ISSUE:	Permit to Demolish and Certificate of Appropriateness for New Construction
APPLICANT:	Eleventh Street Development, LLC
LOCATION:	Old and Historic Alexandria District 101 Duke Street
ZONE:	W-1/Waterfront mixed use zone

Docket #7 & 8 BAR #2021-00495 & 2021-00496 Old and Historic Alexandria District October 6, 2021

Note: Staff coupled the applications for a Permit to Demolish (BAR #2021-00496) and Certificate of Appropriateness (BAR #2021-00495) for clarity and brevity. The Permit to Demolish requires a roll call vote.

Figure 6: Elevation and section at building entry stoops

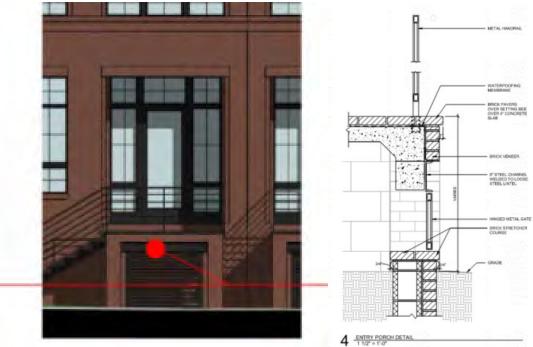
The entry stoops at Union Street vary in height from approximately three feet above the sidewalk to approximately six feet above the sidewalk. This height has been discussed throughout the design review process and is impacted by a number of site considerations. The design for the stoops includes brick steps with a brick landing with a hinged metal gate below and a black metal railing on the south building. On the north building, the design is the same with the exception of the steps, which are metal. The design intent is for the metal railings and the metal gate to recall raised stoops throughout the district. In some of these locations, the gate leads to an entrance to an English basement. Due to flooding considerations, an English basement is not included in this design.

Staff finds that the design for these stoops is a successful reference to historic architecture with a distinctly modern component that indicates this as a new building. The applicant has provided construction sections through the landing at the stoop which show how the brick will interface with the metal gate and the handrail (Figure 6). Staff suggests that the applicant work with staff to develop the final details for the handrail and the metal stairs to a similar level, keeping a reference to historic precedents as the design vision.

- 1. The applicant work with staff on the final details for the entry stoops on Union Street.
- 2. The applicant revise the configuration of the windows on the Duke Street elevation to a more regular spacing that is symmetrical and includes windows on each level.
- 3. The applicant work with staff on the introduction of a reveal at the alley elevation between each townhome to contain the twin downspouts.

Figure 8: View of alley elevation including exposed downspouts

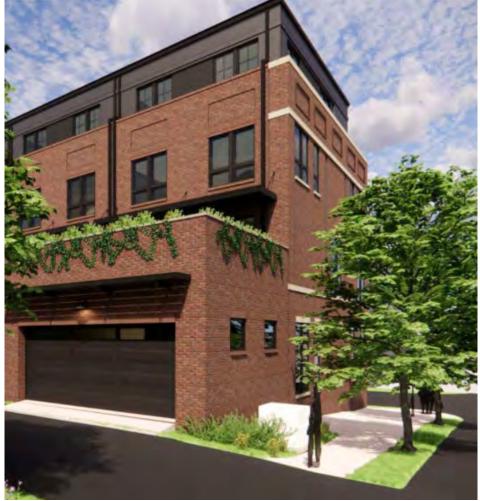
The proposed rear elevation for both buildings is a simplified version of the main elevation that includes double punched windows with brick heads and sills and a simple brick panel above the third-floor windows. This simplified design is appropriate for a rear elevation and staff supports this approach to the design. The applicant is proposing to drain the third and fourth floor roofs to the rear of the site through the use of downspouts that are expressed along the outside of the building. While these downspouts are an important and necessary utilitarian feature, their location protruding from the exterior wall gives an unfinished appearance to this elevation (Figure 8).

Staff recommends that the applicant work with staff to introduce a reveal in this elevation that is similar to the one that has been introduced to the Union Street elevation of the southern building at the break point between each townhome and run the downspouts in this location. This would help to break up the alley elevation into thirds and would organize the downspouts into a discrete location.
